Liveable Neighbourhoods Zone 04 - Winifred's Lane

Stage 3 Road Safety Audit

Bath and North East Somerset Council

Report Title:	Liveable Neighbourhoods Zone 04 Winifred's Lane – Stage 3 Road Safety Audit – Designer's Response
Date:	10 th December 2024
Document Reference & Rev:	60668625-ACM-LN04WL-BNESC-RP-RSA3-0001_P01_Designers Response
Prepared by:	██████████, AECOM
On behalf of:	Bath and North East Somerset Council

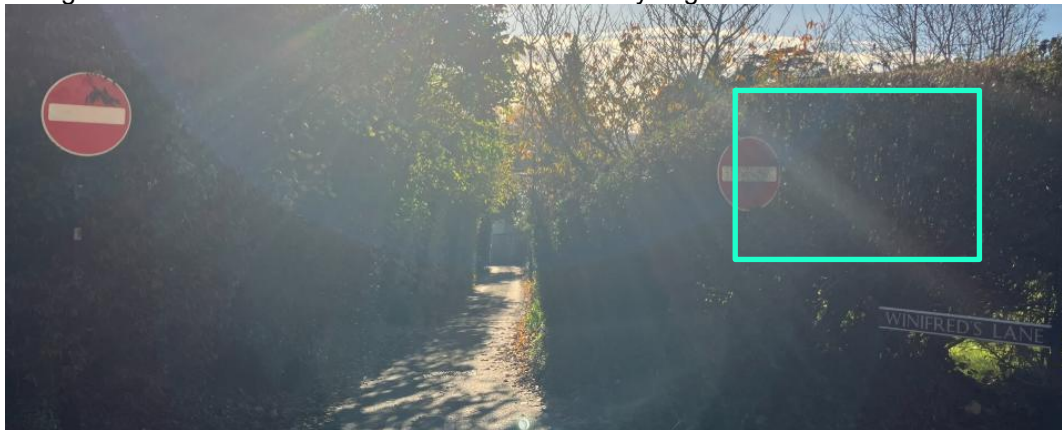
Road Safety Audit Stage 3 Comments:	
<p>During the site visit, the Audit Team observed multiple vehicles turning right from Cavendish Road onto Sion Hill (east). In all instances, drivers carried out this manoeuvre on the incorrect side of the carriageway in order to avoid the new central island (installed to deter drivers from undertaking this exact manoeuvre). This is exacerbated due to the size of the "no right turn" sign faces which appear small and inconspicuous, reducing their visual impact. Therefore, this issue remains outstanding.</p>

It is recommended that the junction is continually monitored and drivers undertaking the banned movement are educated. It is also recommended that the "no right turn" sign faces on approach to the junction are replaced with larger sign faces.

Monitoring of the junction will be undertaken as part of the ETRO process. Discussions are being undertaken by the Highway Authority around the use of camera enforcement for the banned right turn.

The sign faces were specified small as to not negatively impact the conservation area.

Education and enforcement are being considered in this location. A larger sign face will be used in this location to improve their visual impact.
